**DEPUTATION TO PLANNING COMMITTEE
REGARDING PIER 8**

ing By-law Amendment (ZAC-16-034) and Draft Plan of Subdivision (25T-201605)

Made on behalf of Parrish & Heimbecker, Limited (P&H)

May 16, 2017

Noise impact plot – proposed building layout changes

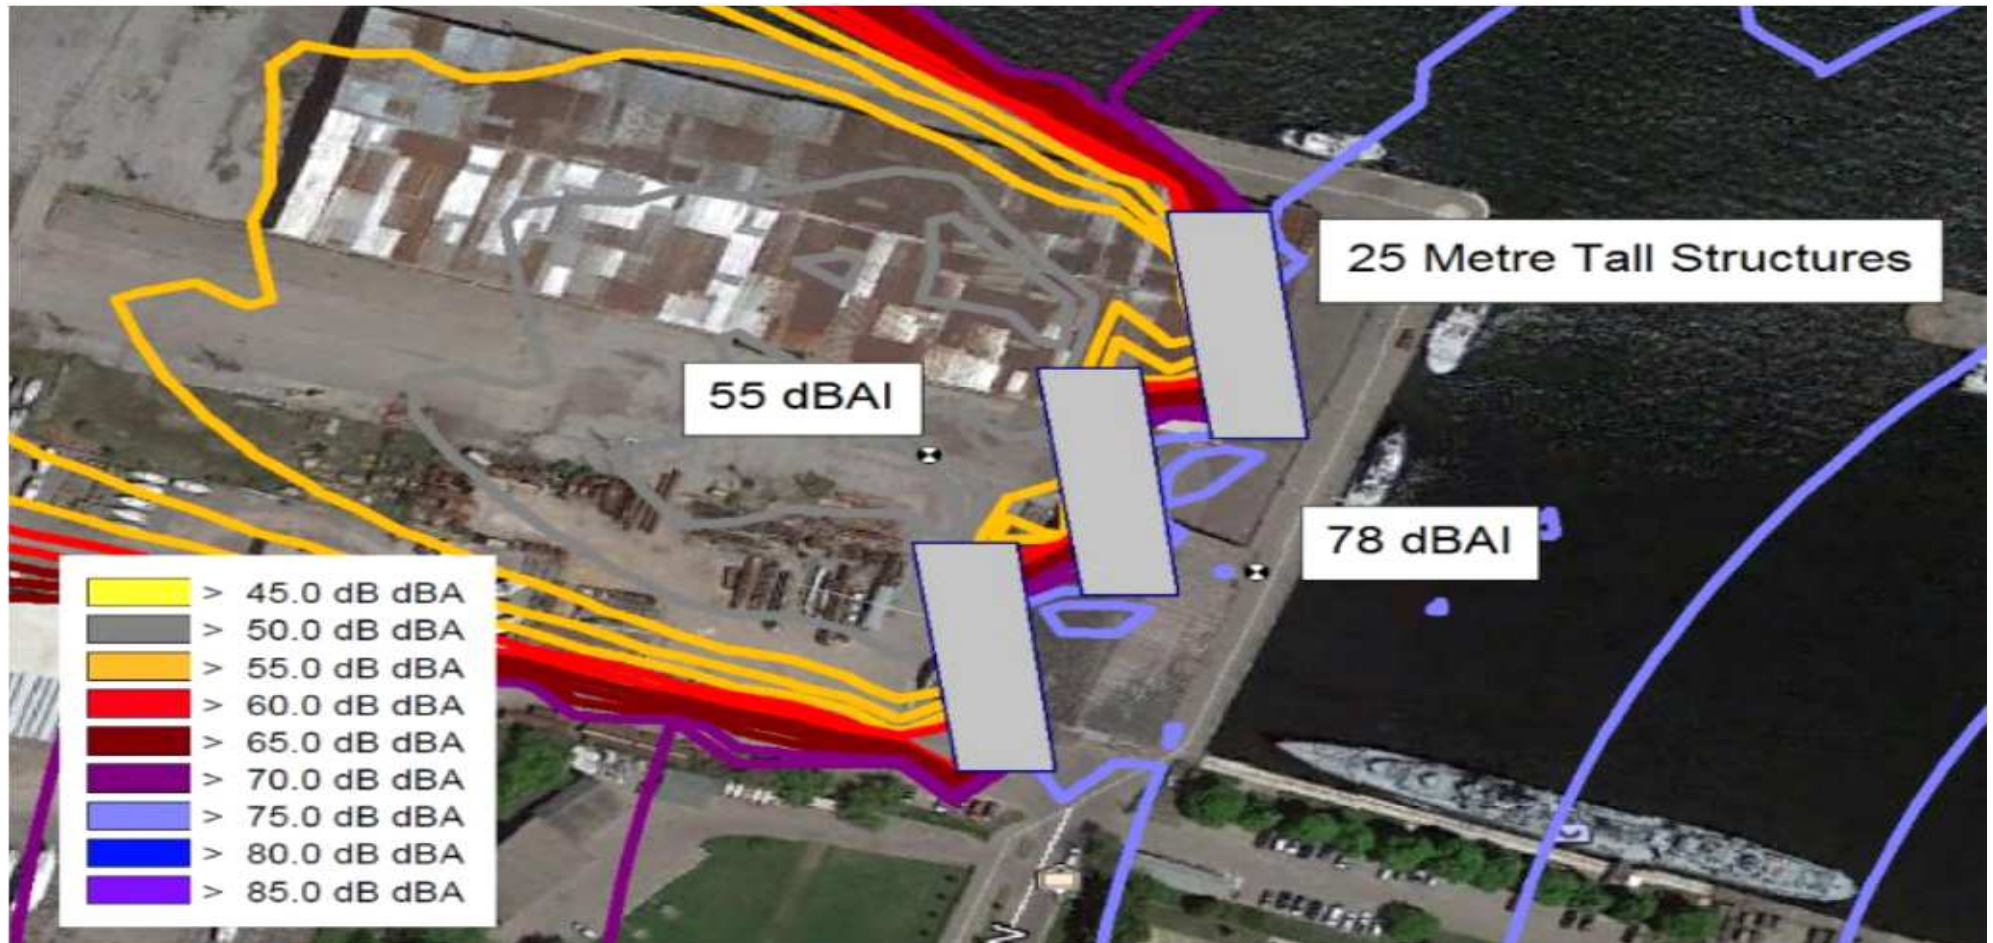
Pinchin 2017:

“Given the stage of the project and the many different possibilities for building design and potential sensitive receptor locations, it is recommended that any proposed building layout concepts and designs be reviewed by a qualified Acoustical Engineering professional prior to any approval in order to ensure compliance with the MOECC guidelines.” [emphasis added]

- Further investigation of noise sources such as shipping required
- Further need to investigate mitigation approaches
- If residential uses allowed to face Pier 10, “extensive” receptor noise control will be needed
- There is a potential impact on P&H operations and permitting
